2 Amendments to the proposal

2.2 Amendments to the proposal arising from the community engagement activities

2.2.1 Refined route

Figure 2.1 Detailed route plan 1 of 7

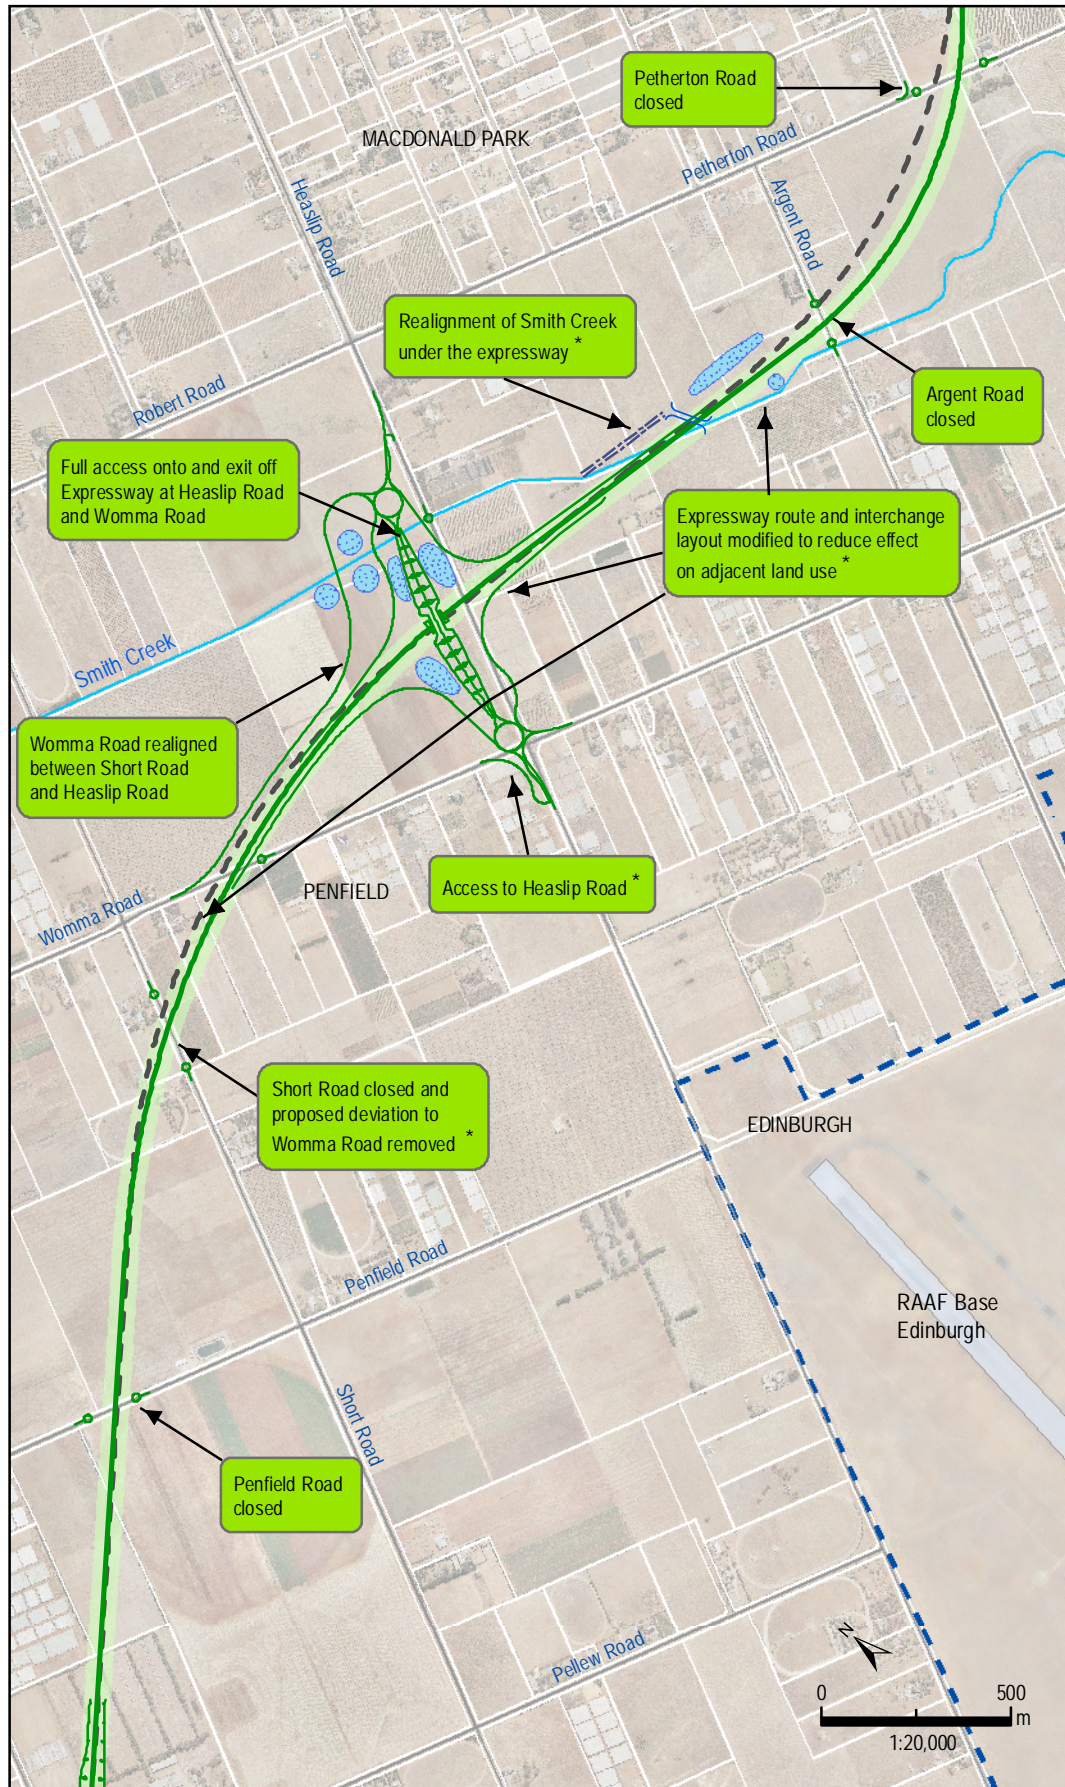
- The proposed Northern Expressway will be moved approximately 20 metres north-west at its intersection with Short Road as part of a design optimisation through which the number of properties potentially affected will be minimised.

- Corridor
- Refined alignment
- Road closure
- Previous alignment in Environment Report
- Changed access via modified service road
- * Amendments to the proposal
